Product Change Notice (PCN)

PCN Number: **PCN-0451169R-01**

Product(s) Affected: **PJ-043H**

PREVIOUS CUI DEVICES DETAIL / IMAGE	NEW CUI DEVICES DETAIL / IMAGE

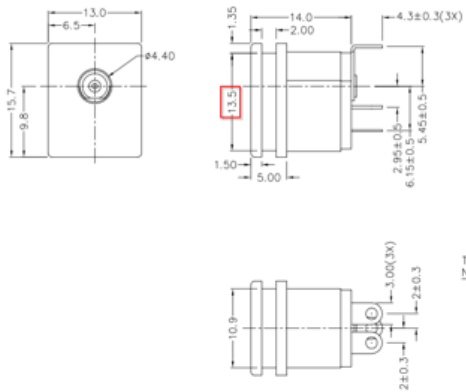
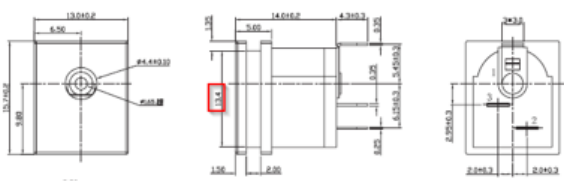
Description of Change: **Minor Housing and footprint differences. Material Change on the housing and terminals. See image Below**

PREVIOUS CUI DEVICES DETAIL / IMAGE			NEW CUI DEVICES DETAIL / IMAGE		
	MATERIAL	PLATING			
center pin	copper	nickel	DESCRIPTION	MATERIAL	PLATING/COLOR
terminal 1	brass	silver	center pin	brass	nickel
terminal 2	copper alloy	silver	terminal 1	brass t=0.35	silver
terminal 3	brass	silver	terminal 2	bronze t=0.25	silver
			terminal 3	brass t=0.35	silver

MATING PLUG
Jack Insertion Depth: 9.50 mm

MATING PLUG
Jack Insertion Depth: 9.0 mm
